**X63 REGIONAL AIRPORT / HURRICANE MARIA DISASTER RELIEF (DR-4339-PR)
PROJECT #85447 / MPPA057 HUMACAO REGIONAL AIRPORT
DR. HERMENEGILDO ORTIZ QUIÑONEZ AIRPORT, HUMACAO, PR**

ADDENDUM NO. 4

RE: PROJECT #85447/MPPA057-HUMACAO REGIONAL AIRPORT (HUC)
RESPONSE TO RFIs

**BID- 1.56
FOR
CONSTRUCTION SERVICES
TO RECOVERY PROJECTS
UNDER THE
FEMA PUBLIC ASSISTANCE PROGRAM FOR DISASTER
DR-4339-PR (Humacao Regional Airport (HUC) Humacao)**

DR-4339-PR HURRICANE MARIA DISASTER RECOVERY
MPPA057 HUMACAO REGIONAL AIRPORT (HUC)
HUMACAO, PUERTO RICO
SITE DEMOLITION PLAN

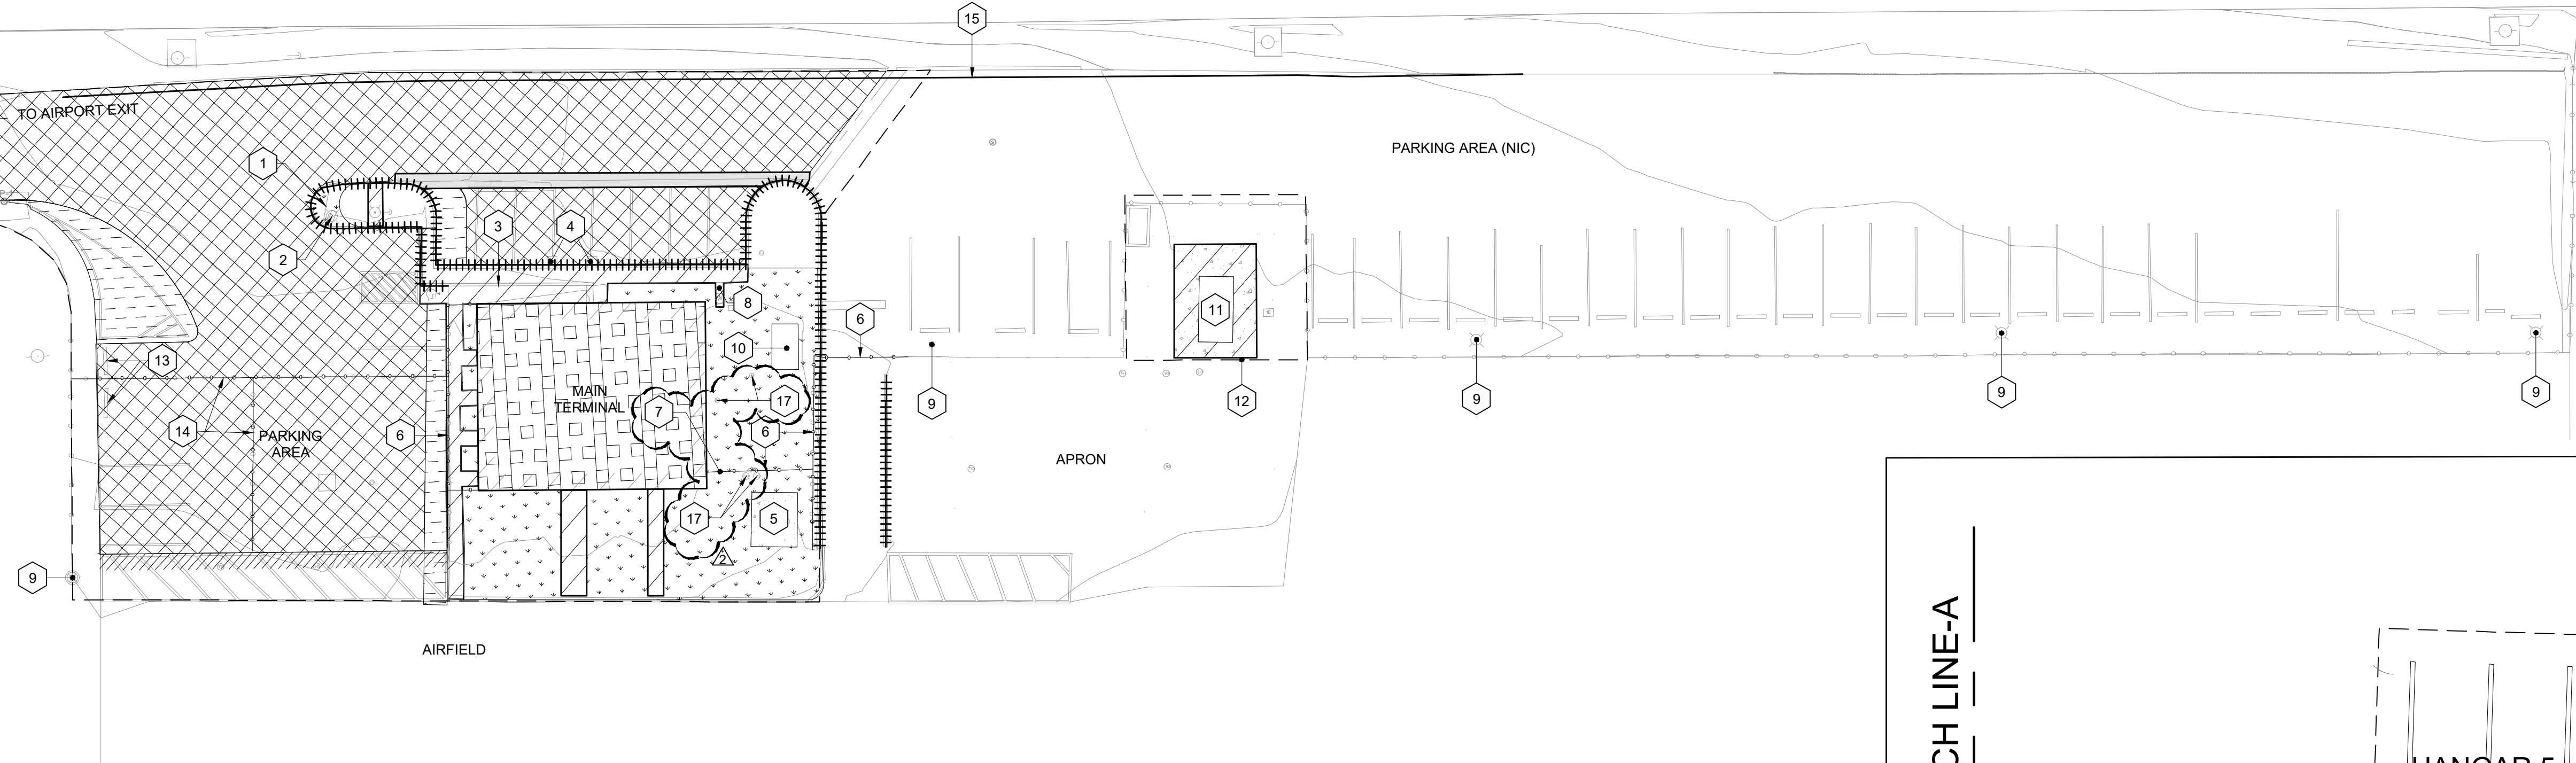
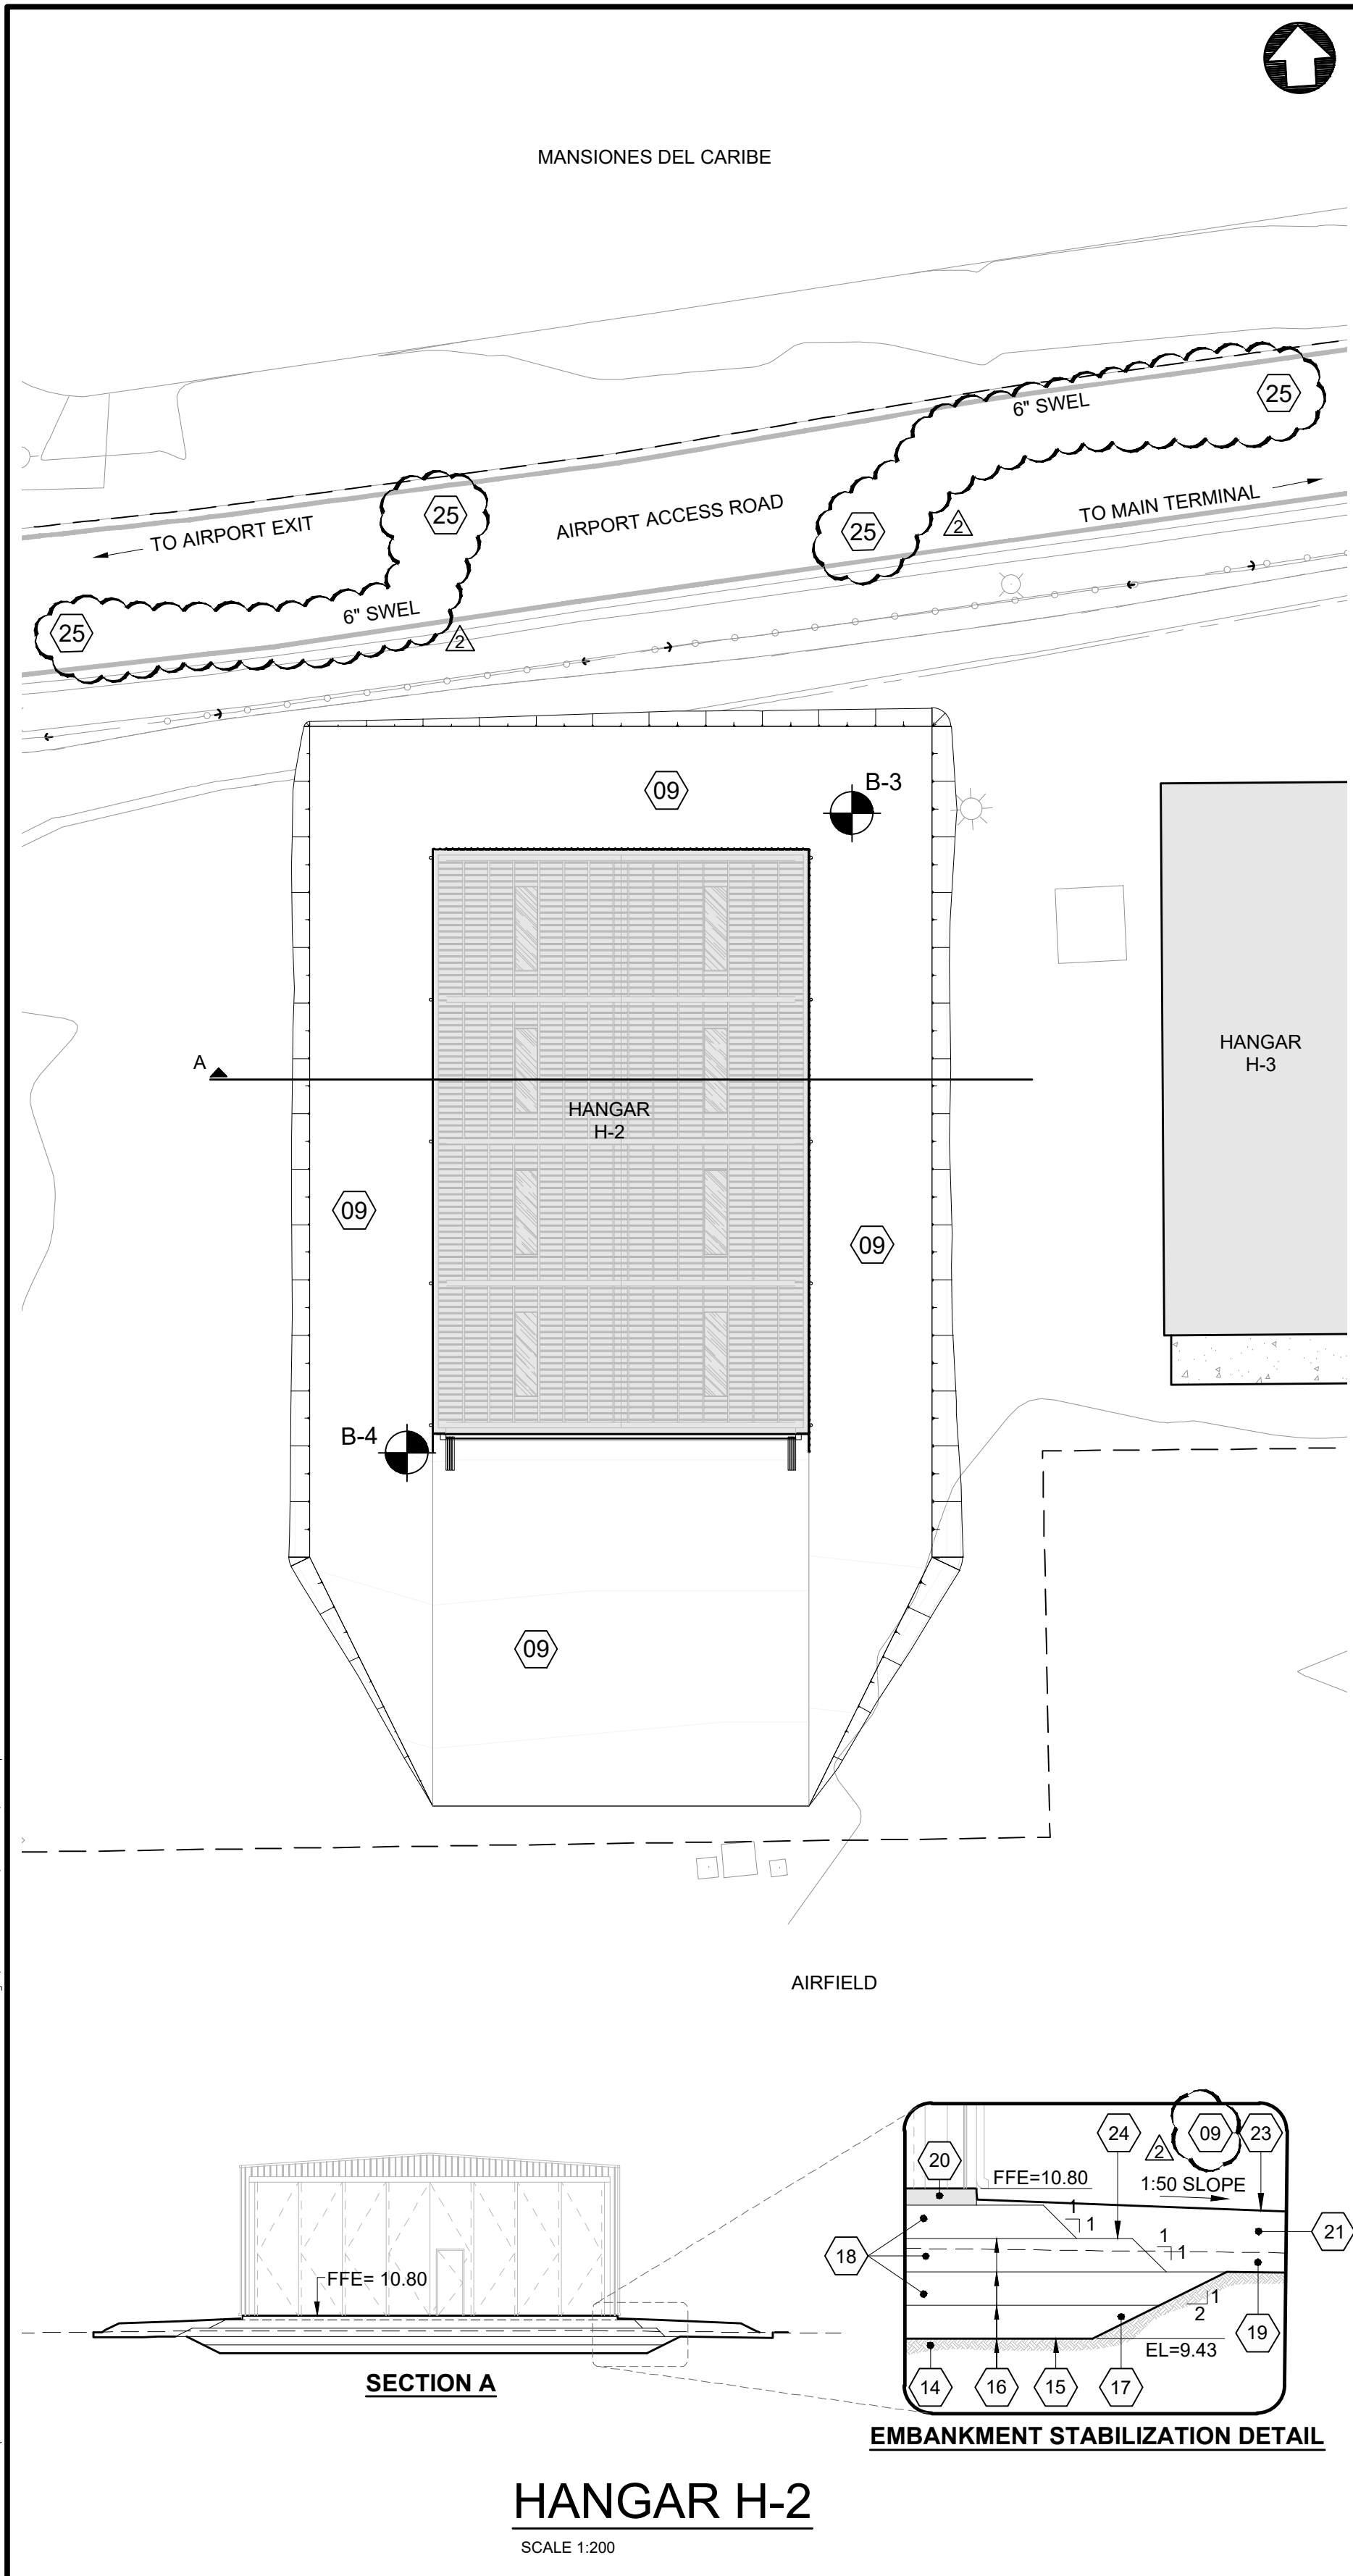
7	En la hoja C006 habla de re-localizar el Airfield Lights Voltage Regulator, pero la 1D-1.1 habla de demoler/remove. Por favor aclarar. De relocalizar favor de proveer detalles de los trabajos en específico y planos para esto. Además, las hojas ES-1.0 y 1E1.1 hablan de que se reemplazará el equipo completamente lo cual no concuerda. De reemplazarse favor proveer más detalles del nuevo equipo a cotizar.	GVG Builders	10/8/25	Sheet 1D-1.1 has been deleted from the set. The Airfield Lights Voltage Regulator will not be relocated. Contractor shall replace existing Airfield Light Voltage Regulator with new Airfield Lights Voltage Regulator, Model L-829, 15kW output, 20-amp output class, 240VAC 60Hz input voltage.
8	¿Las ventanas serán con celocitas en cristal o aluminio?	GVG Builders	10/8/25	The material of the louver windows is confirmed to be aluminum.

- WATER METER SLAB TO REMAIN. PROTECT BOX DURING DEMOLITION.
- EXIST. LIGHT POLE TO BE REPLACED WITH NEW. (SEE LIGHTING PLAN).
- REMOVE AIRFIELD LIGHTS VOLTAGE REGULATOR AND RELOCATED TEMPORARILY. REFER TO AIRFIELD ELECTRICAL DWGS.
